Subject: high peak HPK/2023/0398 - Victoria Mill Woodside Street, New Mills drainage HOLDING OBJECTION

The Network Rail drainage engineers / asset protection team have the following comments:

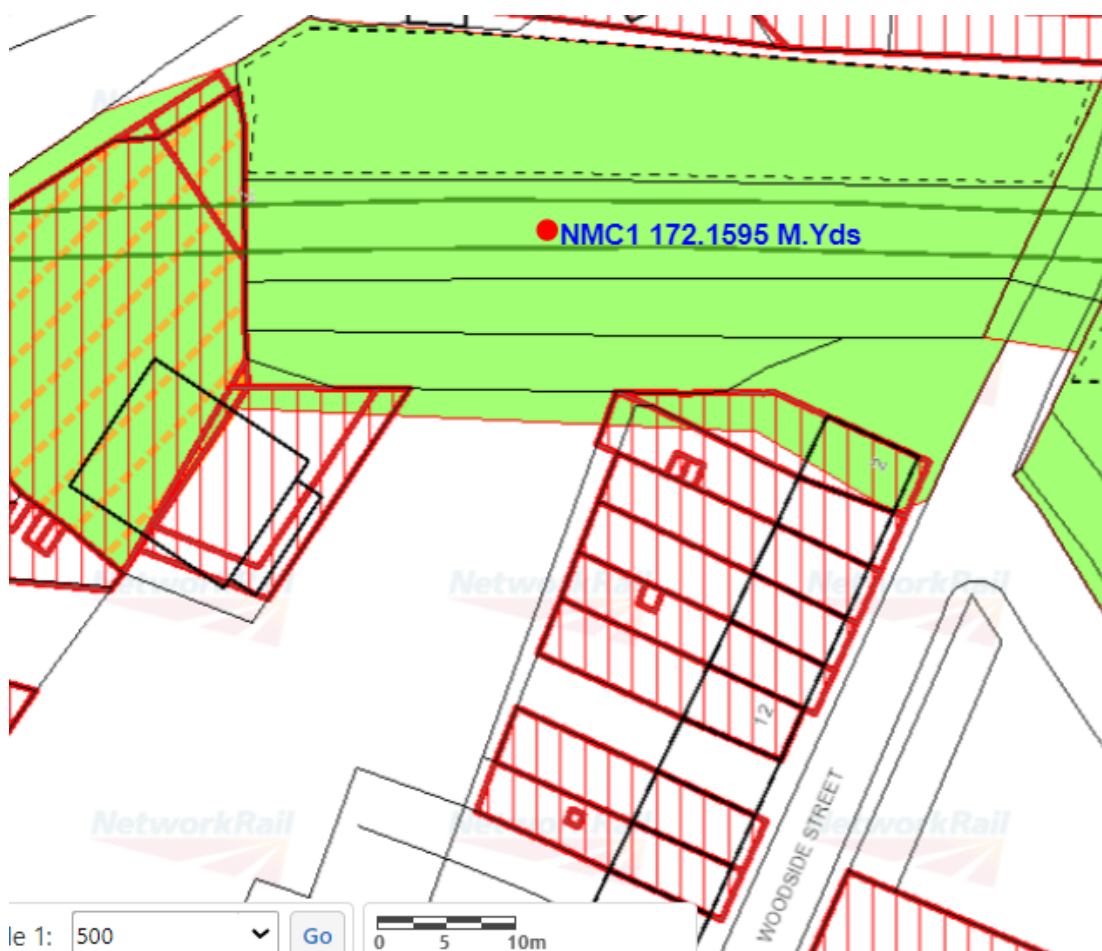
I also note that the site plans provided also seem to incorporate a narrow strip of NR freehold land that presumably is beyond the retaining wall and any physical demarcation boundary line – looking at the extract below, this strip of land should not be included in the developers site plans as they don't have title to the land (and therefore this perhaps provides opportunity for objection).

Please can you ask again for the Outside Party to complete the link for the customer portal and to also ensure that they remove all Network Rail land from the proposal area.
